APPLICATION NO.	FILING DATE	FIRST NAMED INVENTOR	ATTORNEY DOCKET NO.	CONFIRMATION NO.
10/518,435	07/01/2005	Christophe Ripoll	262367US2XPCT	7951
22850	7590	12/30/2005	EXAMINER	
OBLON, SPIVAK, MCCLELLAND, MAIER & NEUSTADT, P.C.			ROSENAU, DEREK JOHN	
1940 DUKE STREET			ART UNIT	PAPER NUMBER
ALEXANDRIA, VA 22314			2834

Office Action Summary	Application No.		Applicant(s)	
	10/518,435		RIPOLL, CHRISTOPHE	
	Examiner		Art Unit	
	Derek J. Rosenau		2834

DETAILED ACTION

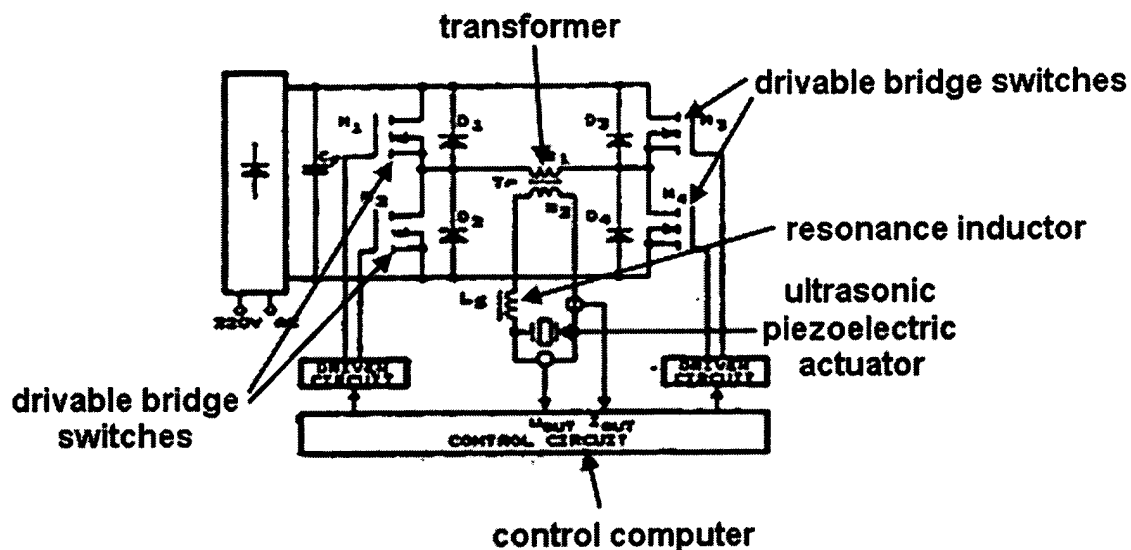
13. Fabijanski discloses a driving device for electronic activation with an ultrasonic piezoelectric actuator (see figure below), a control computer (see figure below), an actuator (see figure below, ultrasonic piezoelectric actuator), a resonance inductor (see figure below), drivable switches (see figure below), and a transformer (see figure below). There are four drivable bridge switches, with a first arm having two drivable bridge switches in series, a second arm in parallel with the first arm, and also is composed of two alternately drivable bridge switches.
